RESPONSE TO REQUEST FOR ADDITIONAL INFORMATION

APR1400 Design Certification

Docket No. 52-046

RAI No.: 401-8402

Figure 6-7 Flow Path for FLEX Connection to Deliver Water to Containment for ECSBS

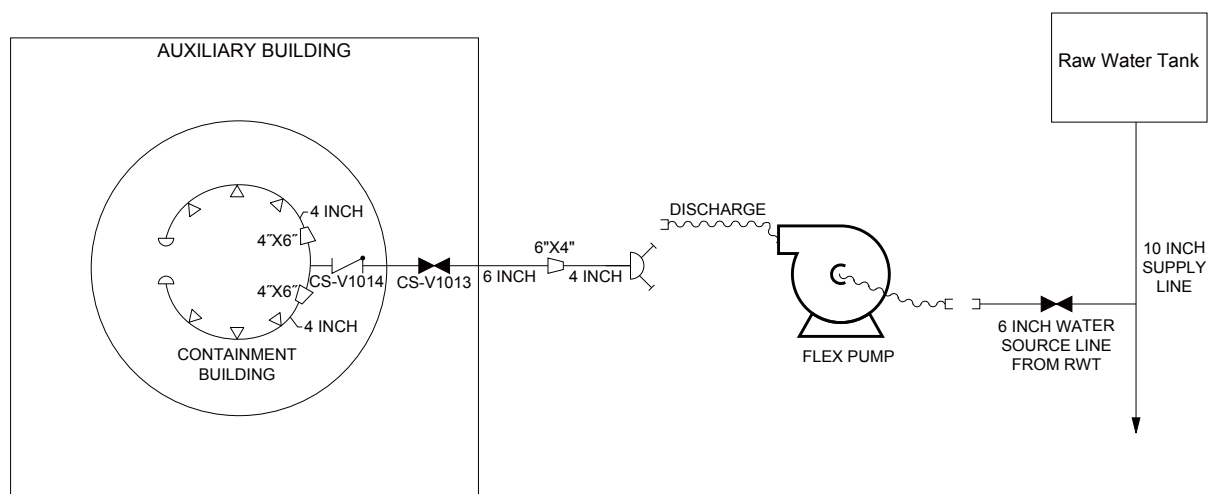
Technical Report APR1400-E-P-NR-14005-P does not contain simplified drawings to show how the FLEX strategy, using the emergency containment spray backup system (ECSBS), is used to maintain containment capabilities. The staff requests that the applicant provide a simplified drawing(s) that identifies the flow path to deliver water to containment. For example the drawing should depict plant piping, valves, pumps, water sources, power needs (as applicable), and any

associated connections (FLEX pump suction, FLEX pump discharge, and fuel supply) and support systems. The staff also requests that the applicant provide the quality classification of installed structures, systems, and components used to maintain containment capabilities. Additionally, the location for any connections should be identified.

The ECSBS can use an external water source from the RWT using the ECSBS FLEX pump, which is connected to the ECSBS via a fire siamese connection located outside of the AB. The ECSBS FLEX pump is self-powered pump (diesel-driven). And the pump is connected to the RWT via a flexible hose on the suction side and is connected to the fire siamese connection via a flexible hose on the discharge side. Fuel is supplied from the diesel fuel oil day tank "A/B" as illustrated in Figure 6-6 of the Technical Report APR1400-E-P-NR-14005-P. A new schematic drawing (Figure 6-7) will be added to the next page of Figure 6-6 and Subsection 5.1.2.5.3 will be revised as indicated in the Attachment.

A simplified drawing that identifies the flow path to deliver water to the ECSBS is schematically shown in Figure 6-7.
